Retrofit Emission Control Devices (REC)**Draft new Regulation on uniform provisions concerning the approval of Retrofit Emission Control Devices (REC) for heavy duty vehicles, agricultural and forestry tractors and non-road mobile machinery (NRMM) equipped with Compression Ignition engines.**

Draft Version 3 dated 01.12.2011

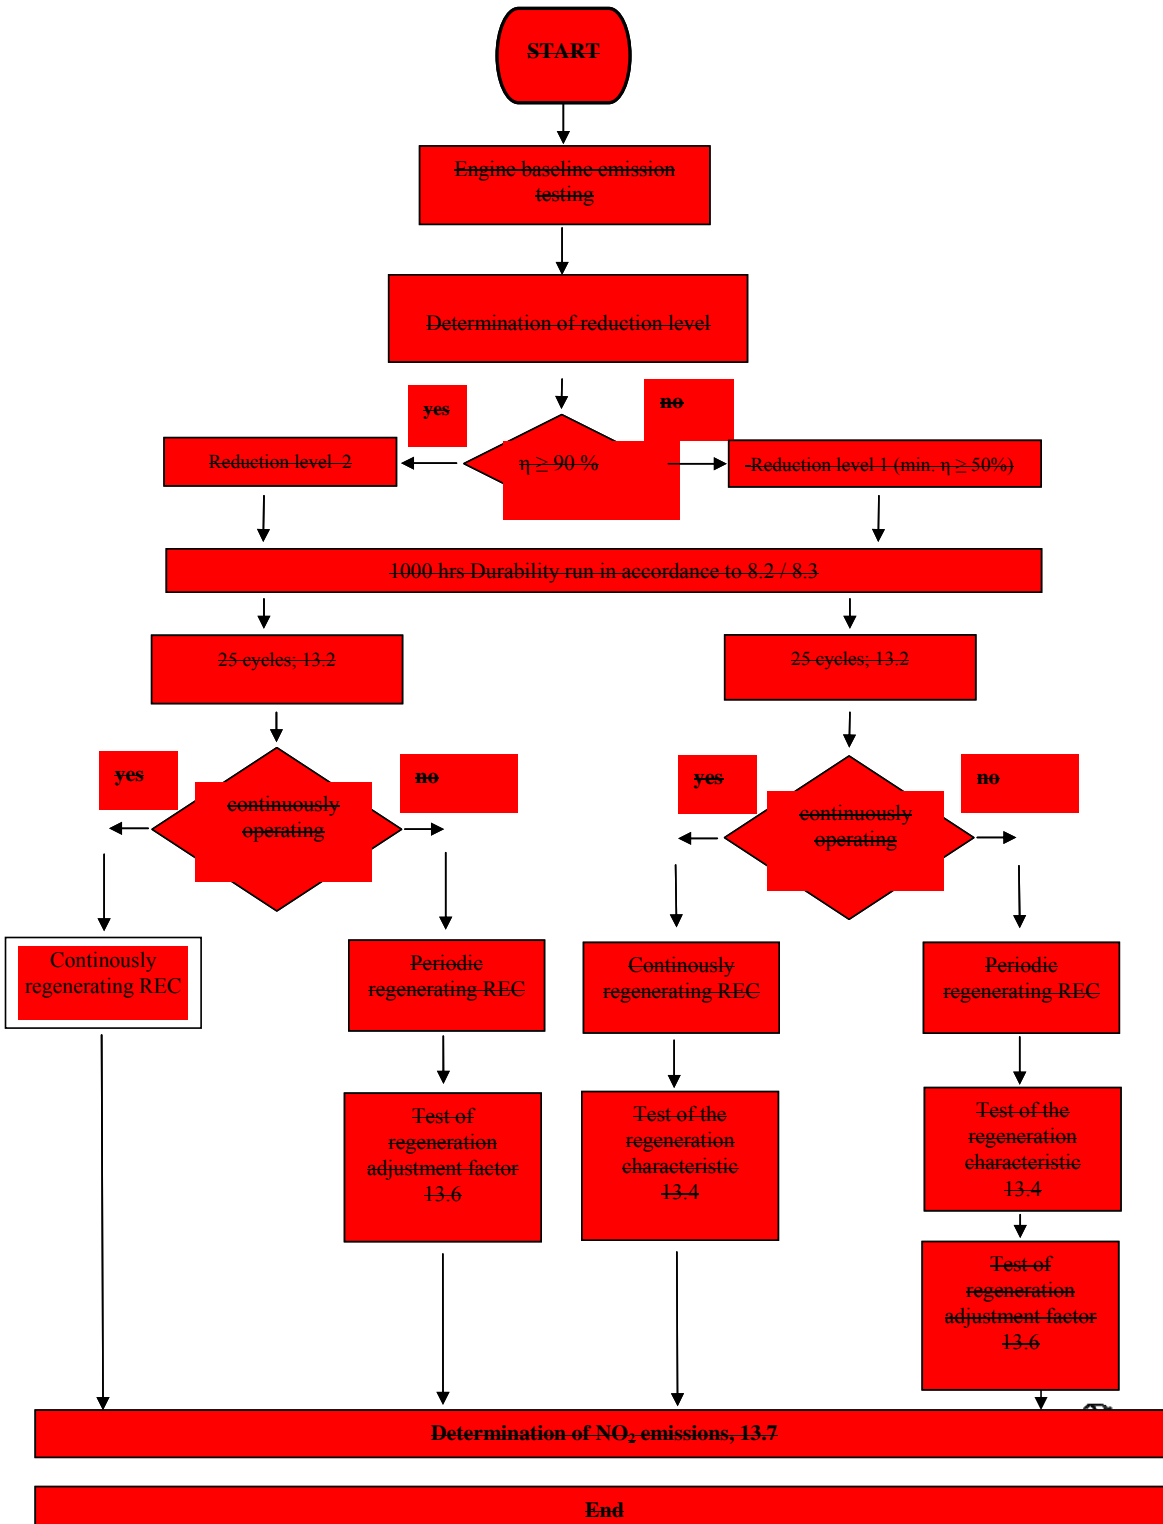
Comment [JM31]: To be reviewed; new approach on the test cycles has to be included

Comment [DB32]: Cycles; 25 cycles for regen. etc TBD

Test sequence for a REC

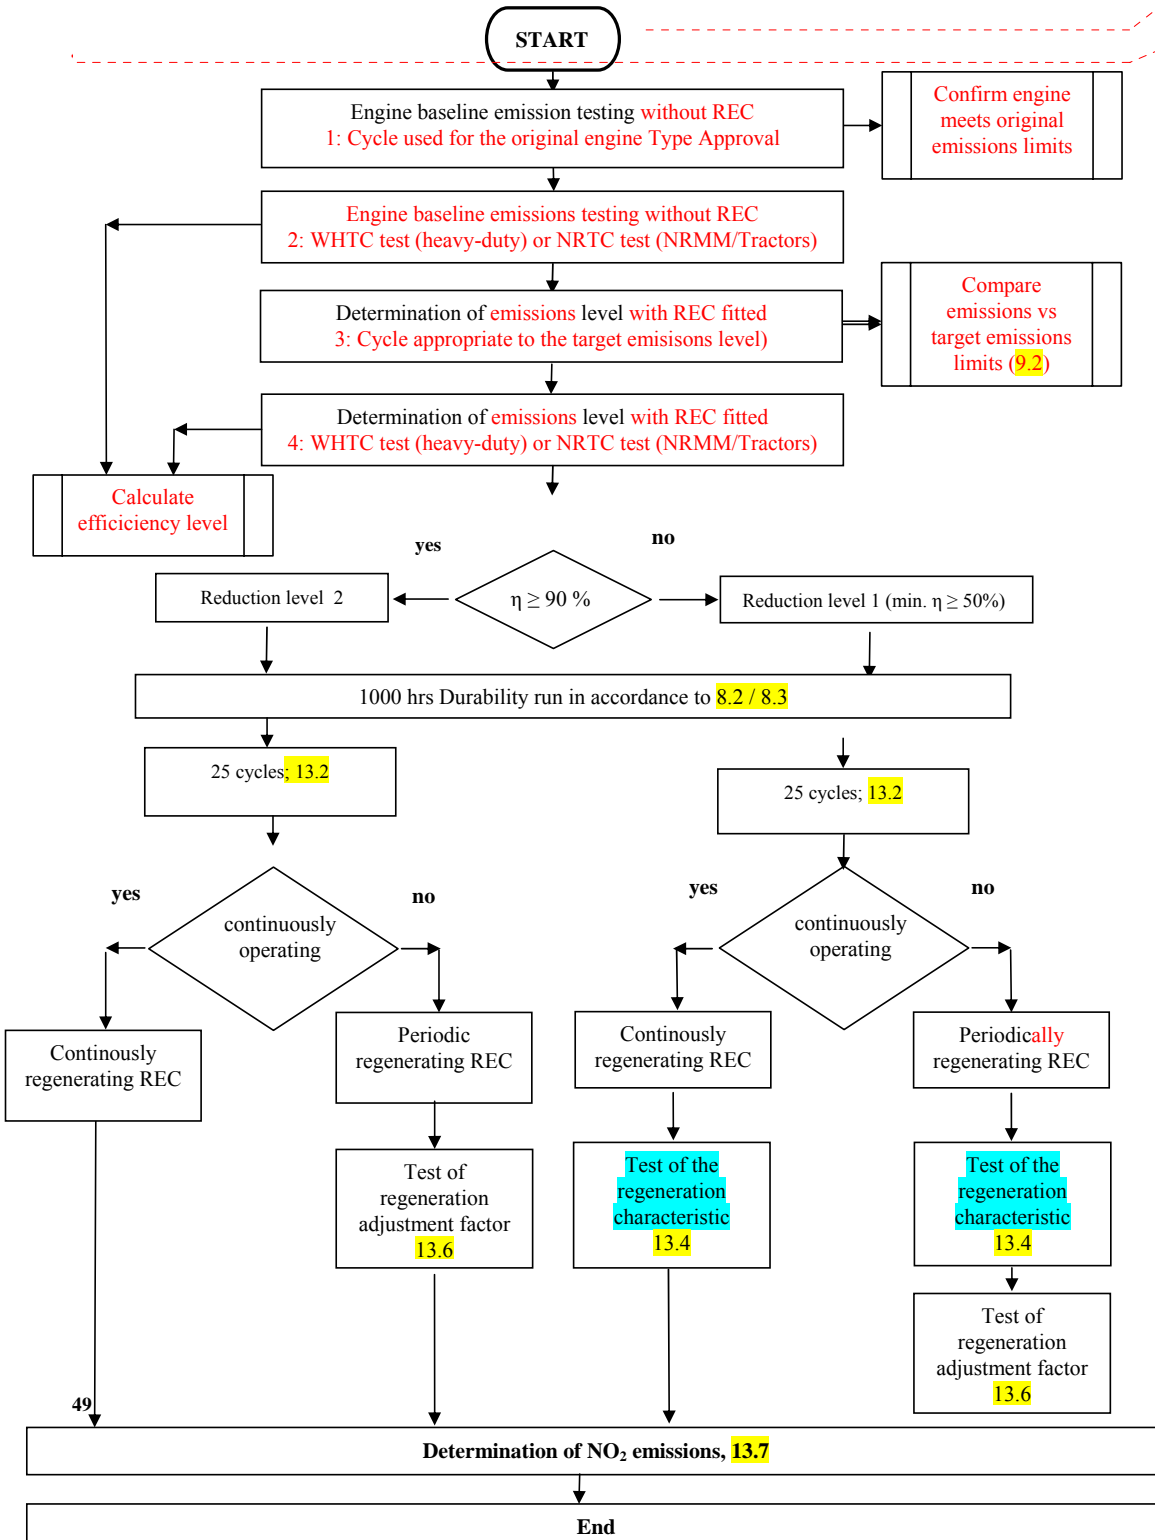
Comment [JMY33]: Can PM & NOx reduction be combined in 1 flowchart?

Comment [JMY34]: Why are the two efficiency legs different in treatment of system regen?
